# Downtown Code DRC Meeting of 6/3/22

# DTC Concept Plan and Modification 125 7<sup>th</sup> Ave N. (Nashville Marriott) 19 – O'Connell Matt Segrest, Alamo Manhattan Properties Brooks *Approve with conditions*.

# DTC MODIFICATION REQUEST SUMMARY

#### PLAN DETAILS

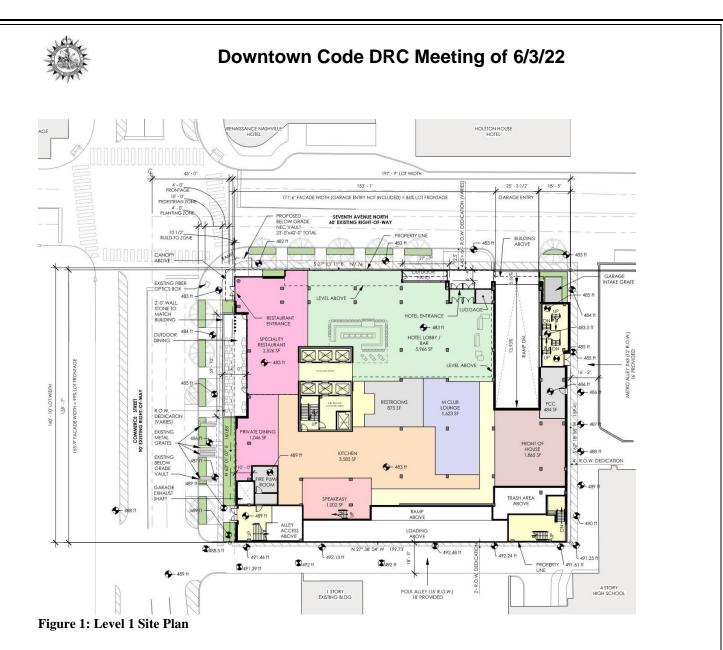
The general bounds of the property include Commerce Street to the north, 7<sup>th</sup> Avenue North to the east, and alleys to the west and south. The site shares access to these alleys with historic Hume-Fogg High School, its neighbor to the south and southwest.

The site contains two street frontages. The Commerce Street frontage serves as the pedestrian entrance to a restaurant and includes an outdoor dining space. The Seventh Avenue North frontage is characterized by the hotel entrance and lobby, as well as the garage entry.

Along Commerce Street, four remnant parcels owned by MDHA (7 ft deep) are situated between the proposed site and public right-of-way. The applicant is working with MDHA to obtain an easement for right-of-way dedication, outdoor dining, planting beds, and pedestrian space on the MDHA-owned property.

Loading and other back-of-house uses are proposed for the west façade, along Polk Alley.

• Is the project successfully responding to the context of neighboring historic structures, including Hume-Fogg High School?

The project generally aligns with the goals and objectives of the Downtown Code to create active, attractive streets and streetscapes. Staff recommends approval with the following conditions:

- 1. The applicant shall provide documentation of their agreement with MDHA for an easement enabling sidewalk improvements on its property.
- 2. The applicant shall work the NDOT to complete a Traffic Impact Study prior to Final Site Plan Approval.
